Subject: Byron Station Units 1 and 2  
Braidwood Station Units 1 and 2  
Notification of Bases Changes to the  
Technical Specifications  
NRC Docket Nos. 50-454/455 and 50-456/457

ATTACHMENT A  
SUMMARY OF PROPOSED CHANGES

FIGURE 1

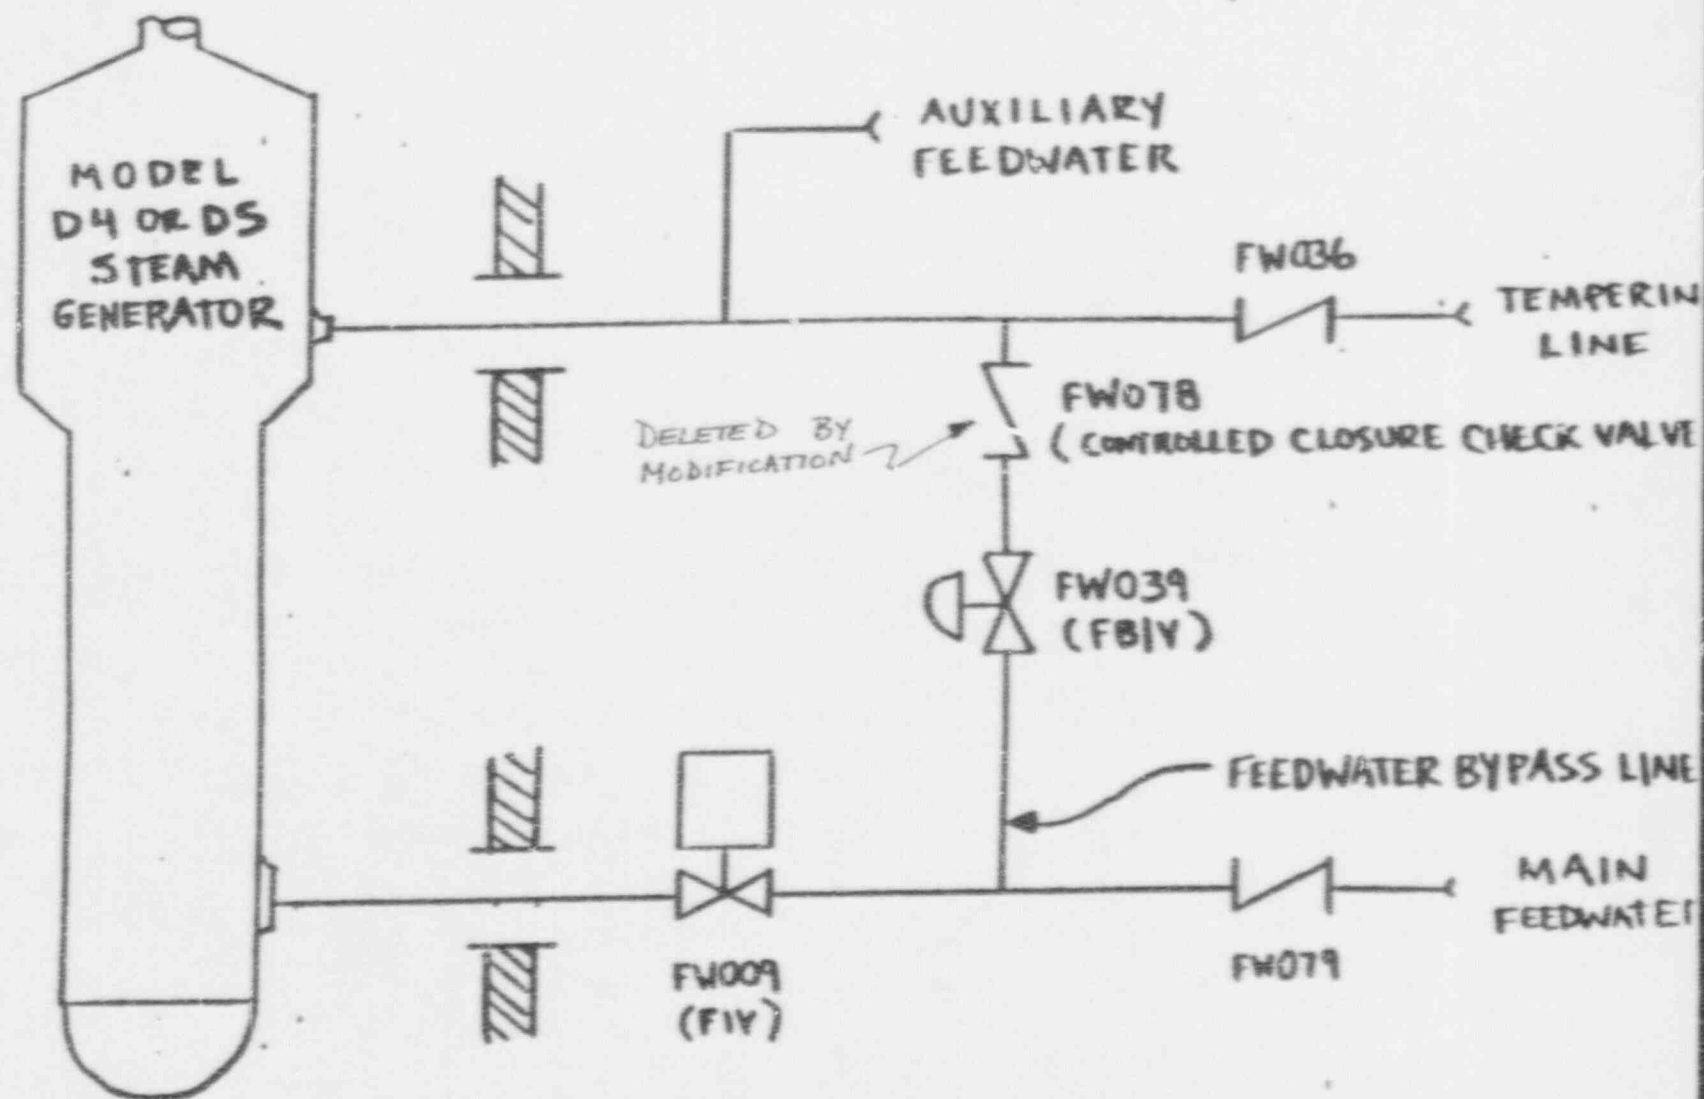
This bases is being changed to delete the reference to a Low T-ave signal in the discussion of the actuations associated with the P-4 interlock. The modification performed affecting this bases involved the removal of the check valves in the feedwater bypass lines to optimize the feedwater flow distribution between the upper and lower nozzles under full power conditions. This modification also deleted the Low T-ave input to the Feedwater Isolation logic, such that a Feedwater Isolation signal is generated with any P-4, or Reactor Trip signal. The previous configuration generated the Feedwater Isolation only if the P-4 signal existed coincident with a Low T-ave signal. The purpose of removing the Low T-ave input is to ensure a Feedwater Isolation on all Reactor Trips. This would protect the steam generator preheater section from water hammer due to the introduction of cold Auxilliary Feedwater into the preheater. With the feedwater bypass line check valves removed, a flowpath from the tempering line to the main feedwater line via the feedwater bypass line was created, absent prompt operator action to manually close the bypass line isolation valve. The modification ensures the preheater will be protected from waterhammer due to cold Auxilliary Feedwater flow automatically upon receipt of a Reactor Trip signal. A simplified diagram of the feedwater arrangement is attached.
